**ALAMEDA POINT
MASTER INFRASTRUCTURE PLAN
ADDENDUM SHEET**

The Final Master Infrastructure Plan (MIP) for Alameda Point will incorporate the following addendums to the Updated Draft MIP, dated October 31, 2013.

FIGURE 58 PHASE 1A "TOWN CENTER"

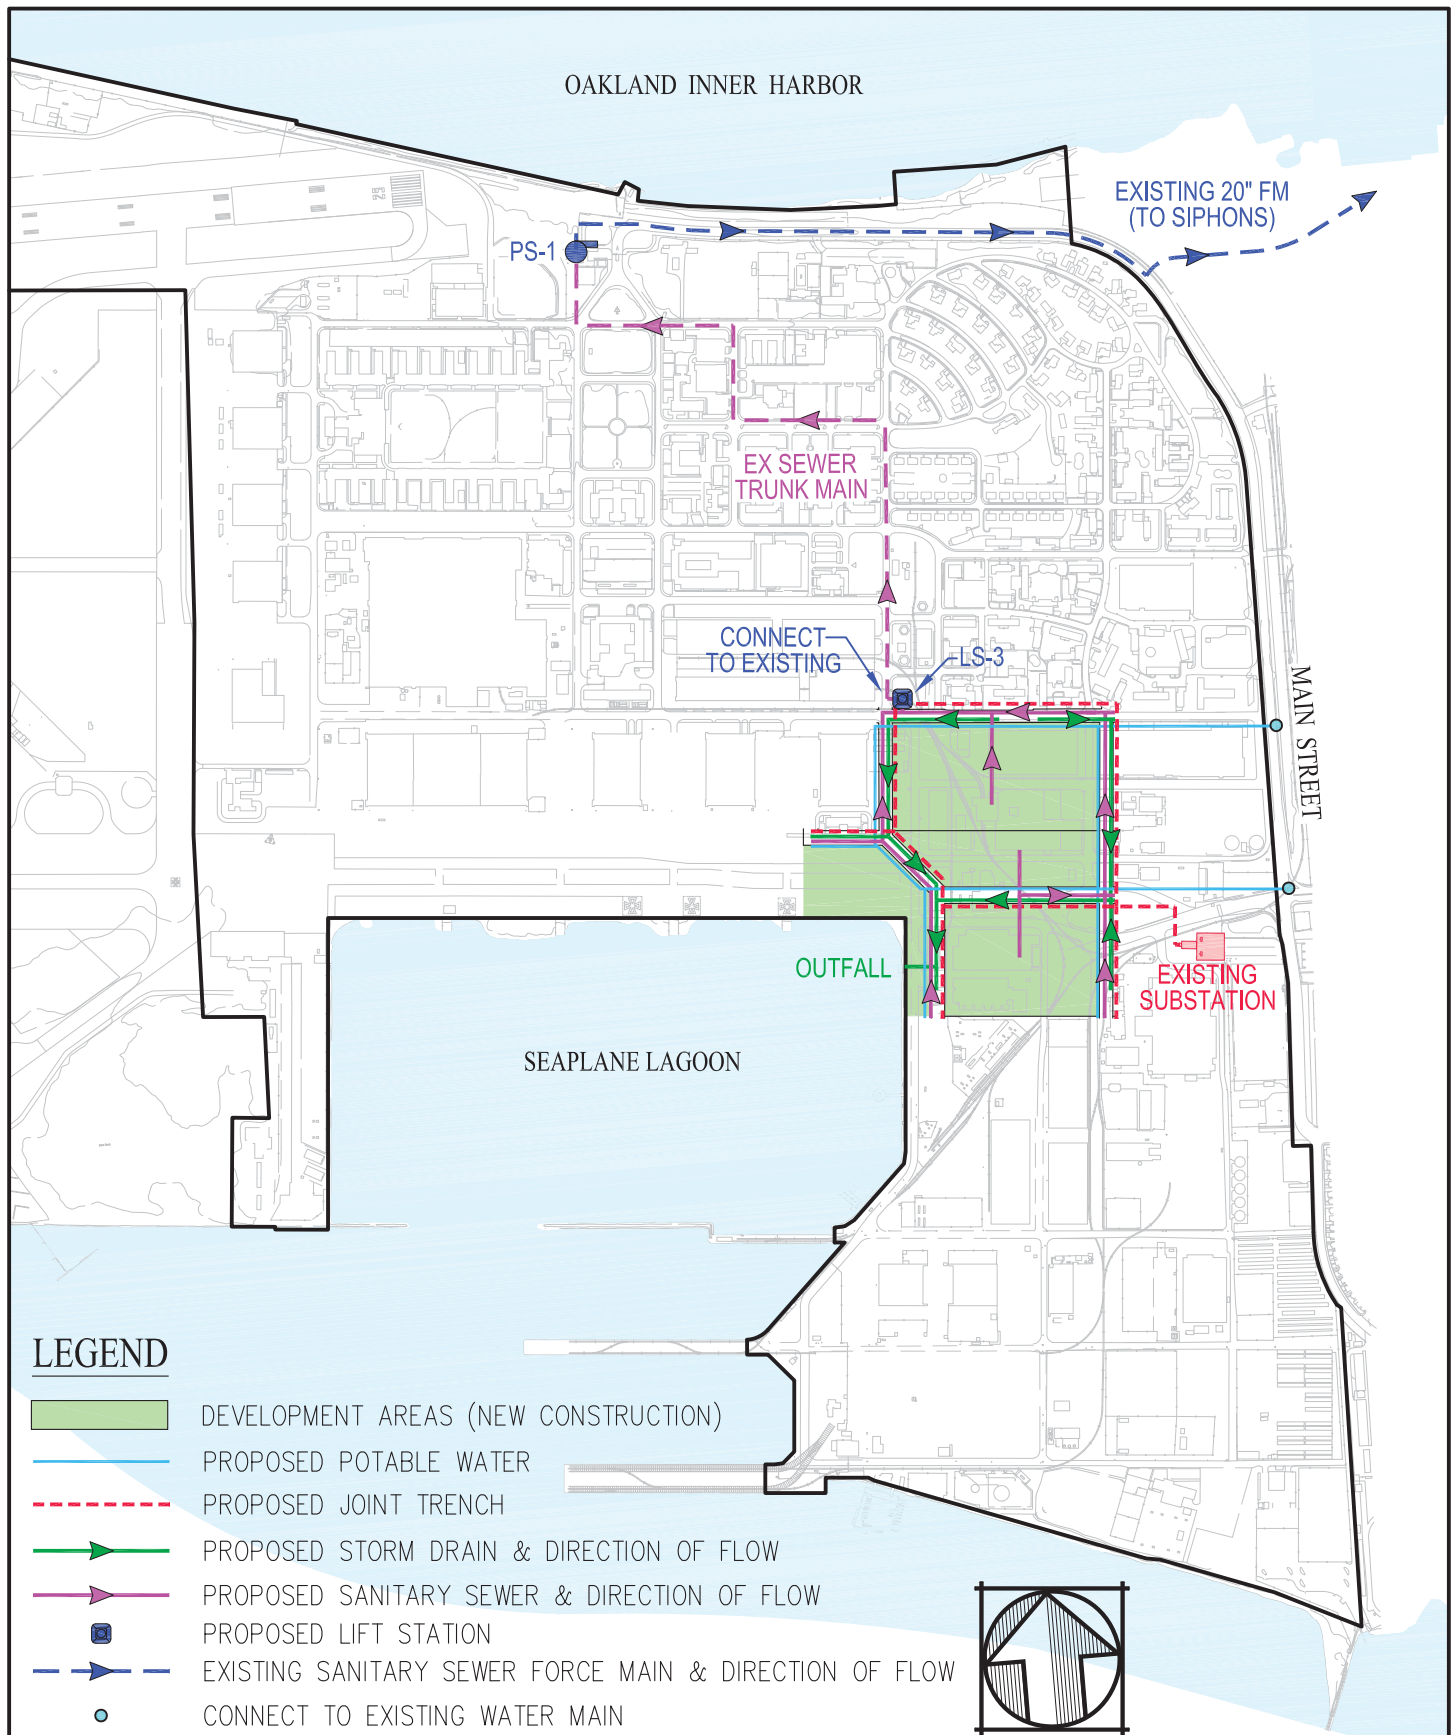
Update Figure 58, Phase 1A “Town Center”. (See attachment)
